## ADDENDUM #1

Reference: Fire Alarm System Upgrade – Cedar City Firth District Court  
Administrative Office of the Courts  
DFCM Project No. 06109150

**Subject:** Revisions to Fire Protection Drawings for Addendum 1

MAIN FLOOR/  
BASEMENT  
FA-1

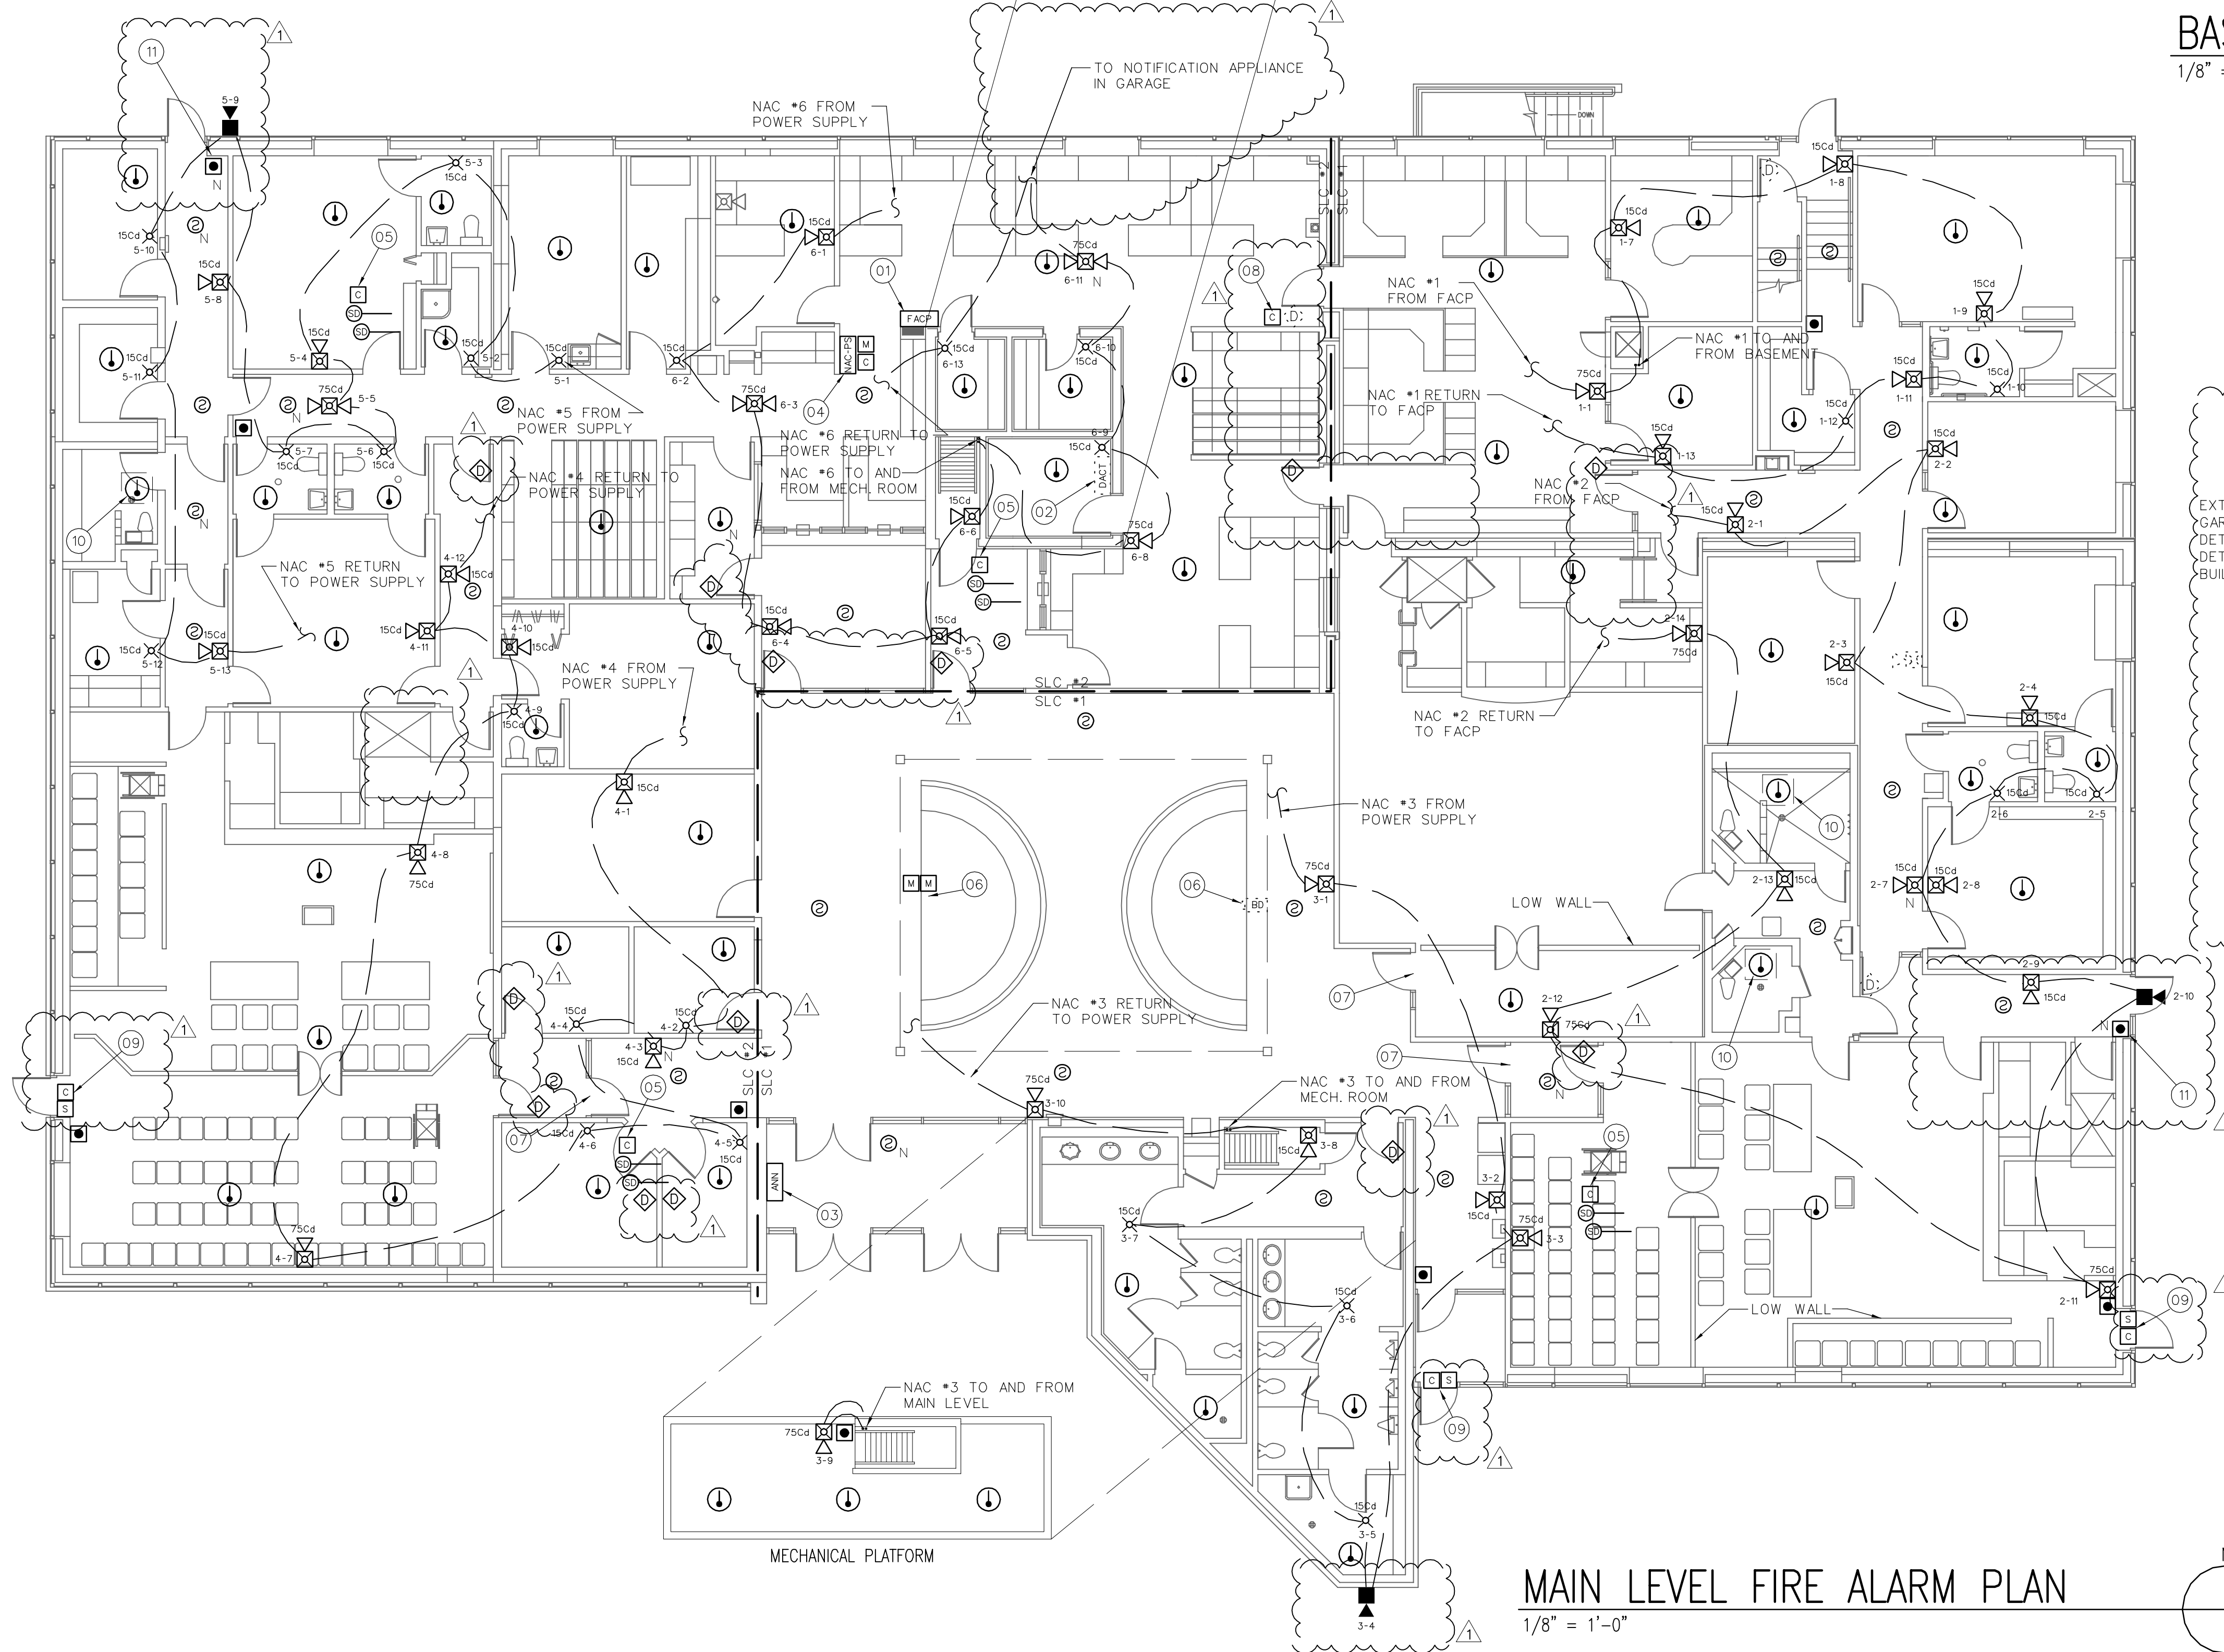
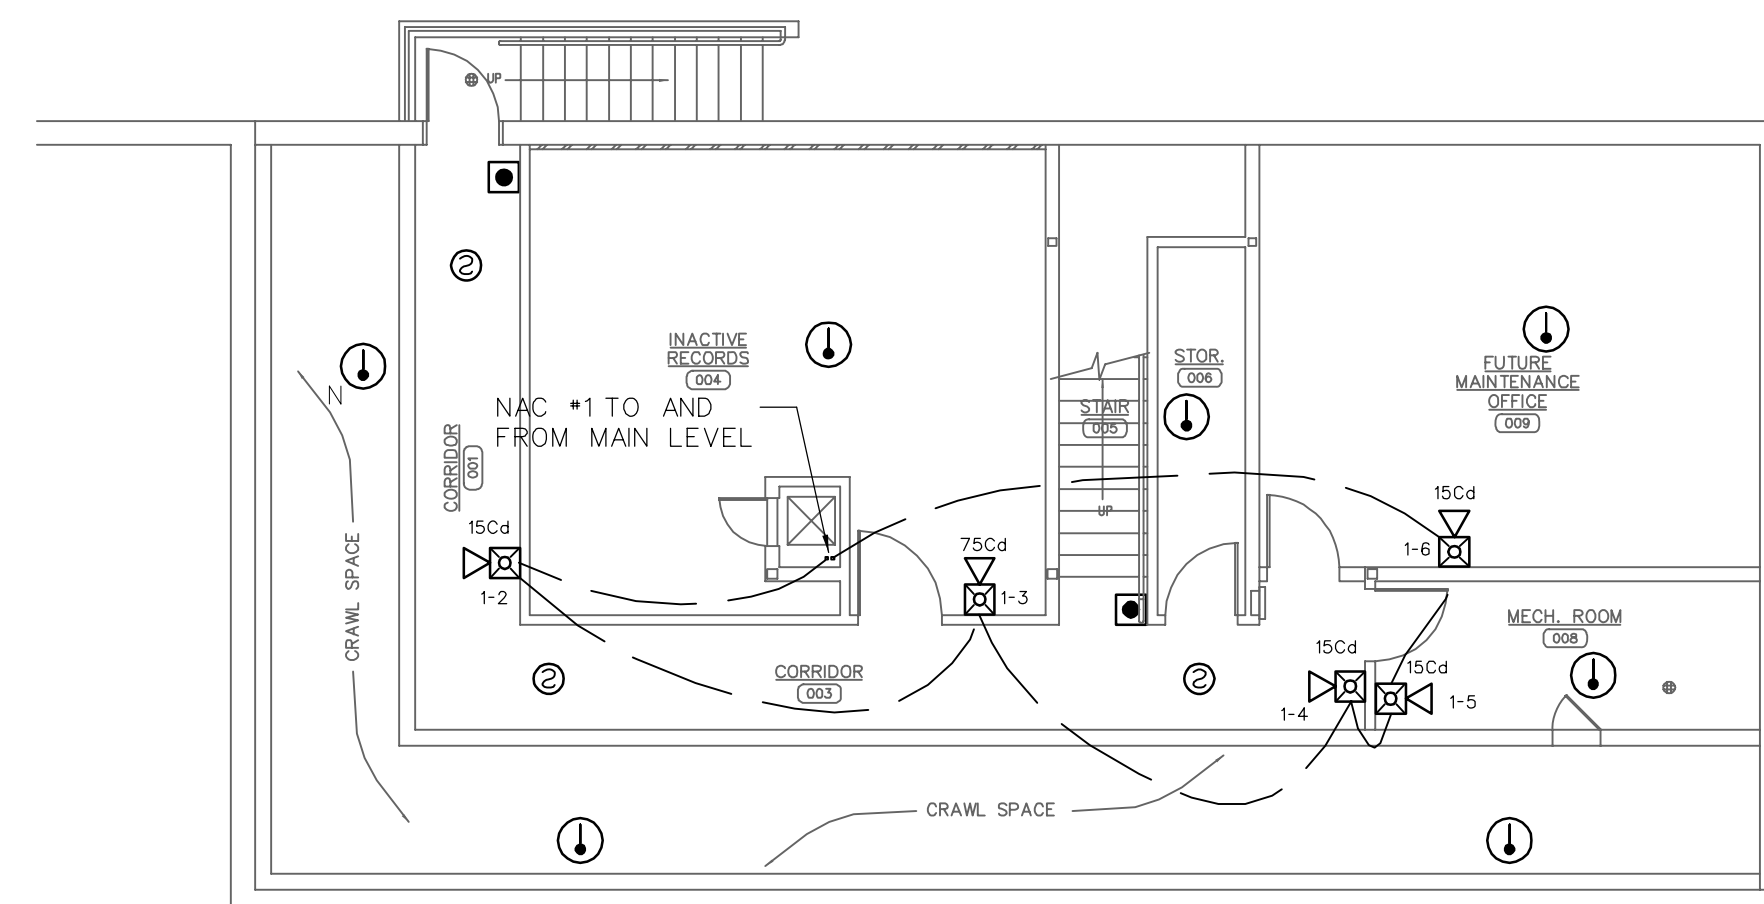
**Sheet FA-1:**

1. Added the garage to the plans. One notification appliance, one pull station and one detector must be replaced in the garage. The type of detector provided in the garage shall be a heat detector.

2. Added three exterior fire alarm horns. The new horns will replace existing devices.
3. Revised the drawings to eliminate fire alarm interface with card access doors separating the courtrooms from the secure area of the building.

4. Added flush mounted door strikes and control relays at three exit doors to allow fire alarm system to bypass existing delayed egress locks.
5. Added one existing door holder that was missed on bid plans.

6. Added 13 new magnetic door holders as directed by Dwight Palmer during pre-bid walkthrough.
7. Revised general note 5 to clarify requirement for painting wall (or providing cover plate) where new wall mounted devices are smaller than existing devices that are replaced.

8. Added protective covers with tamper alarms to new pull stations at two secure exits.
